# ARCHITECTURAL REVIEW COMMITTEE MEMORANDUM

SUBJECT: A REQUEST BY JERRY G. JOHNSON, ON BEHALF OF V.I.P. MOTOR

CARS, LTD., FOR A MINOR ARCHITECTURAL (MAA) APPLICATION FOR A PARTIAL DEMOLITION, A 1,973-SQUARE-FOOT ADDITION, AND EXTERIOR ALTERATIONS TO AN EXISTING AUTOMOTIVE DEALERSHIP BUILDING, GENESIS PALM SPRINGS, LOCATED AT 4057 EAST PALM CANYON DRIVE (APN: 681-070-034), ZONE C-2, SECTION

30 (CASE 3.1358 MAA). (NK)

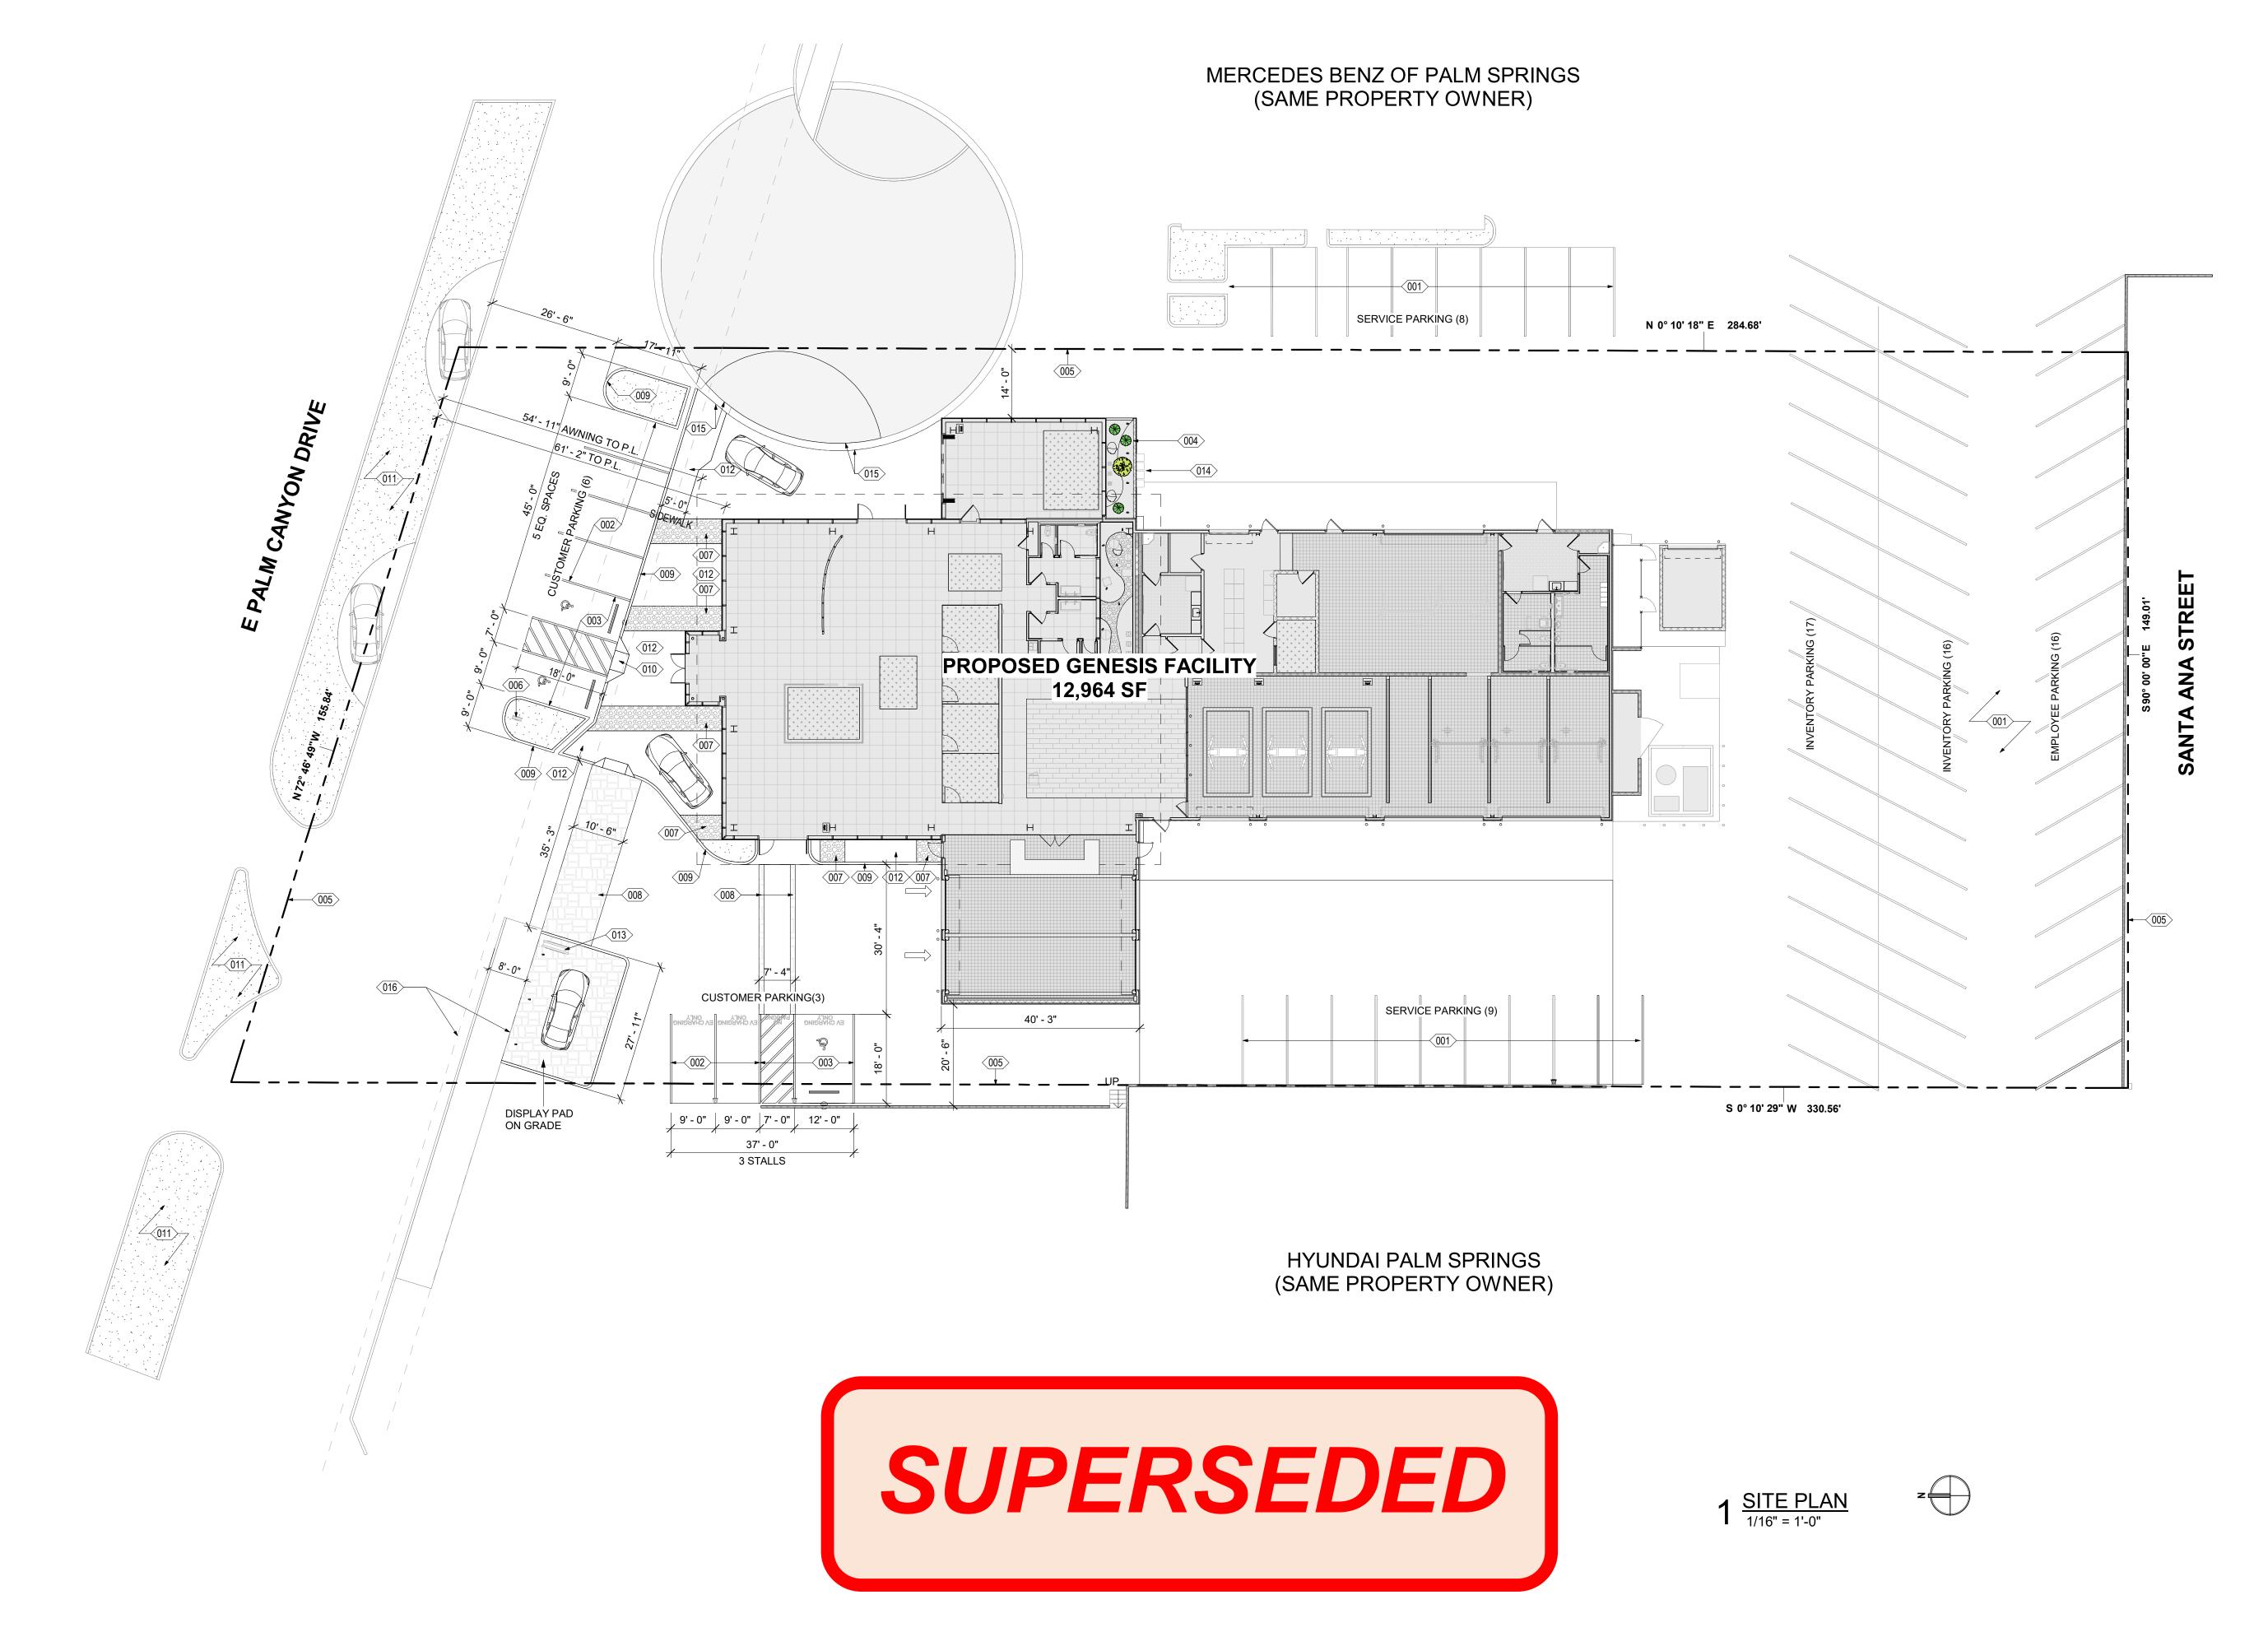
- 1. Except for one, the proposed parking area planting beds do not meet the minimum planting bed width of 9 feet required by the zoning code.
- 2. Only one plant material (Red Yucca) is proposed for the new parking area planting beds; there is no shade tree proposed for the new customer parking areas.

The primary customer parking area (north side) includes two planting beds, one of which is only 7 feet in width and substandard to the minimum planting bed width requirement of 9 feet. To address this issue, staff is recommending a condition of approval which requires the width of the 7-foot-wide planting bed to be increased to 9 feet. In addition to the primary parking area, the proposed secondary customer parking (west side) also includes a planting bed which is nonconforming to the minimum width requirement. Staff recommends a condition of approval which requires the conversion of the north-end handicapped space into a standard parking space and omission of the adjacent walkway to provide a 9-foot-wide planting bed and an 8-foot-wide access path for the handicapped/EV parking space as required by the zoning code. The conversion of one handicapped space into a standard parking space remains compliant as the zoning code requires two handicapped off-street parking spaces while the project currently proposes three.

Palm Spring Zoning Code Section 93.06.00(C)(3)(a) requires at least 30% of the parking area to be developed with shade trees. The proposed plant palette includes Red Yucca only, and there is no shade tree proposed. Staff is recommending a condition of approval which requires an increase in plant diversity and arrangement of the plants to achieve better composition, as well as the installation of shade trees in the new planting beds.

- 1. Convert the north-end handicapped space in the secondary customer parking area (west side) into a standard parking space and omit the adjacent walkway to provide a 9-foot-wide planting bed. Increase the shared pathway adjacent to the handicapped/EV charging space to 8 feet.
- 2. Increase the 7-foot-width of the planting bed in the primary customer parking (north side) to 9 feet to meet the code requirement.
- 3. Increase the plant diversity and arrange the plants to achieve better composition. Install shade trees in the new planting beds.

1 NORTH ELEVATION  $\frac{1}{1/8"} = 1'-0"$

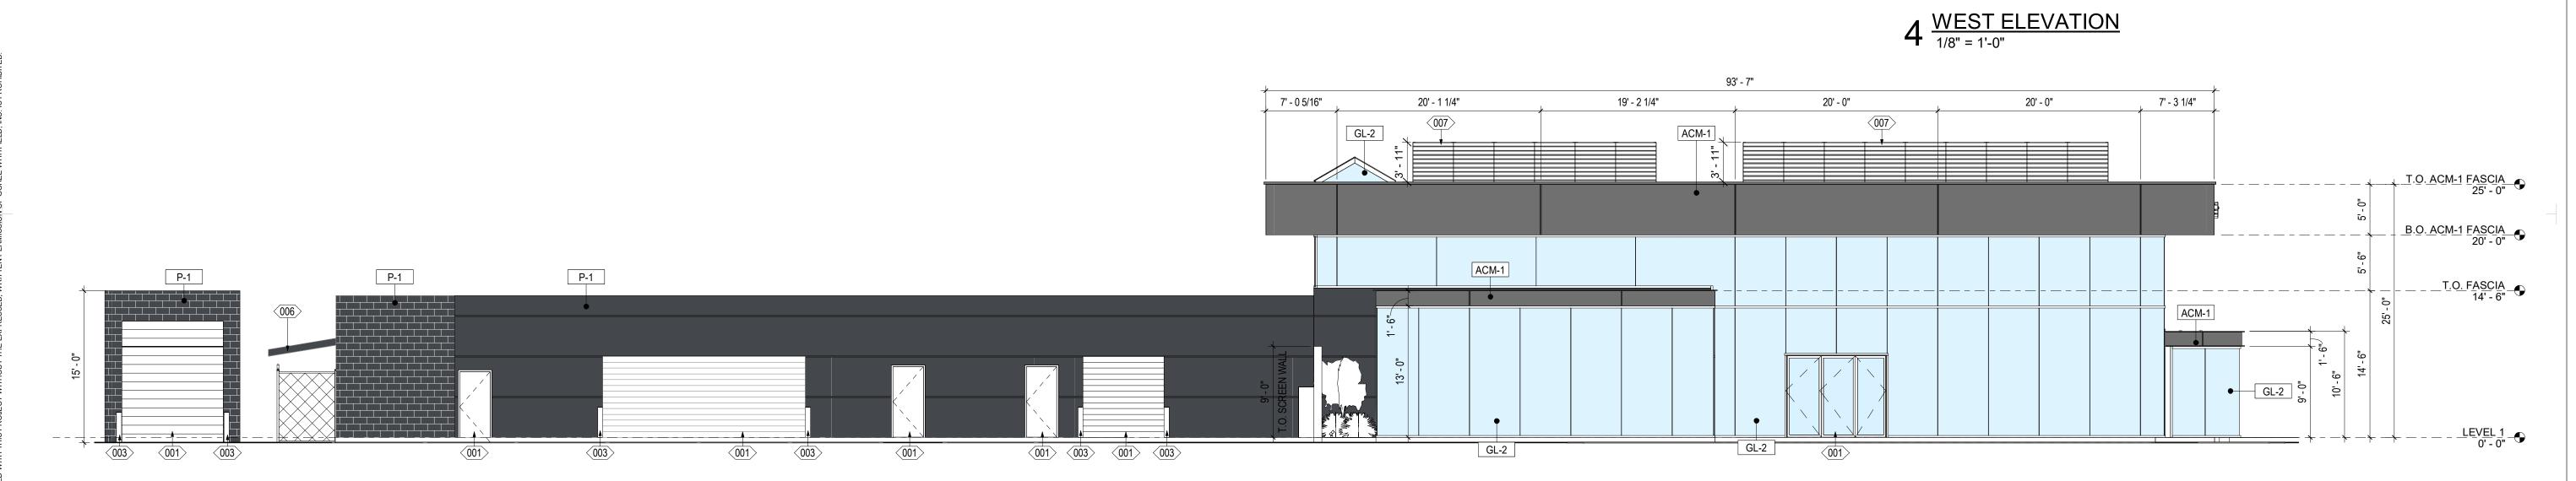
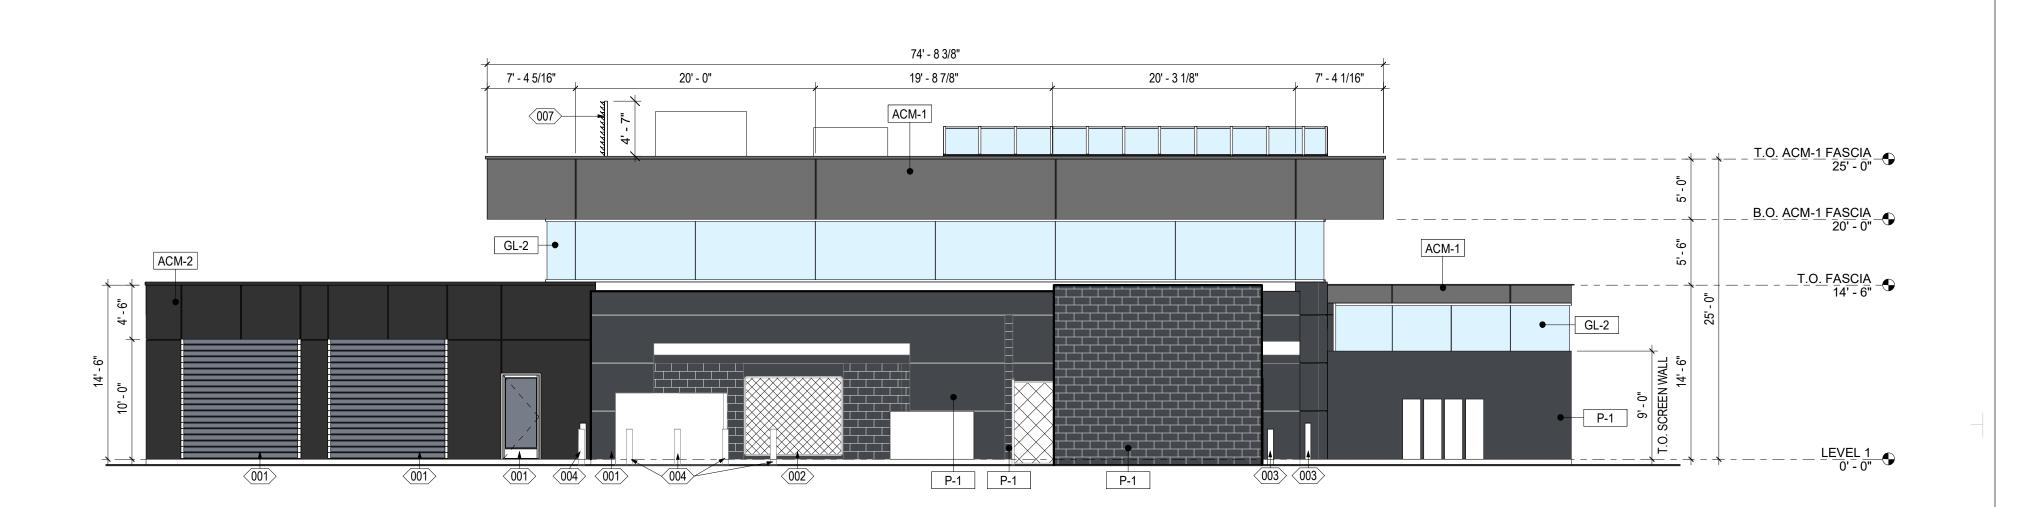
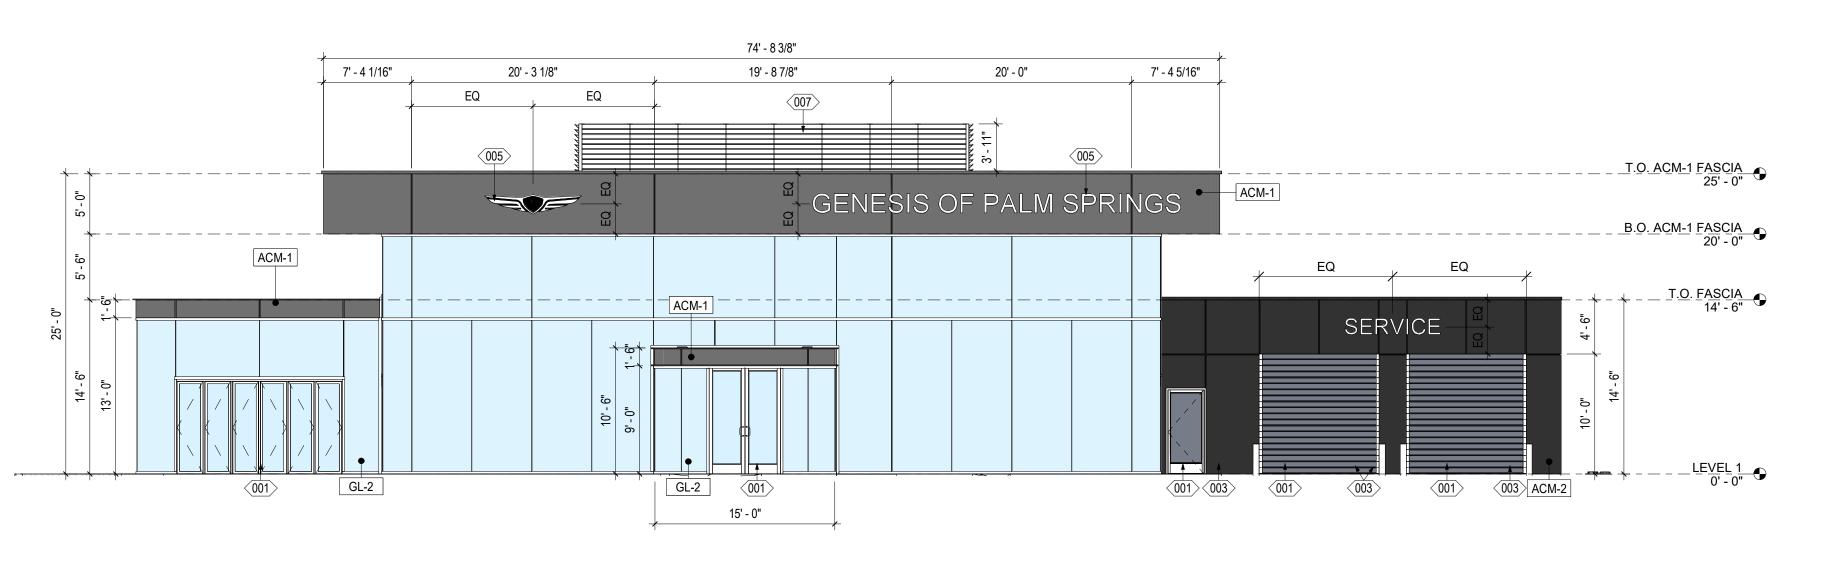
Chair Jakway stated that the proposed roof over the projecting entry door on the front elevation appears weak, and an increase in the volume of the roof similar to the main roof may add some strength to it. Chair Jakway agreed with the previous comments by Member Doczi regarding the landscape design and stated that the project site needs more landscaping.

Chair Jakway stated that the incorporation of a large glazing area on the north elevation is reasonable as it does not face a solar gain issue. However, such design treatment on the east and west side elevations needs to be reconsidered. Chair Jakway added that the interior shades take away the design intent of the

The "floating roof" design and the use of glass as shown in our plans are essential elements of Genesis' international design intent. The roof as designed does have a five-foot overhang providing some benefit.

- We will use efficient glass. Genesis specifications for glazing is Solarban 72 solar control low-e glass for dual glazed units with ½ inch air space, a very efficient solution.
- With approval from Genesis, we can further enhance the glazing by adding Optigray coating. This coating further reduces the heat gain coefficient and visible light transmittance.
- We can also add mechanical shades to the interior of the east and west side glazing for use seasonally during a few hours a day of direct sunlight. We are providing photos of this solution in use at Hyundai.
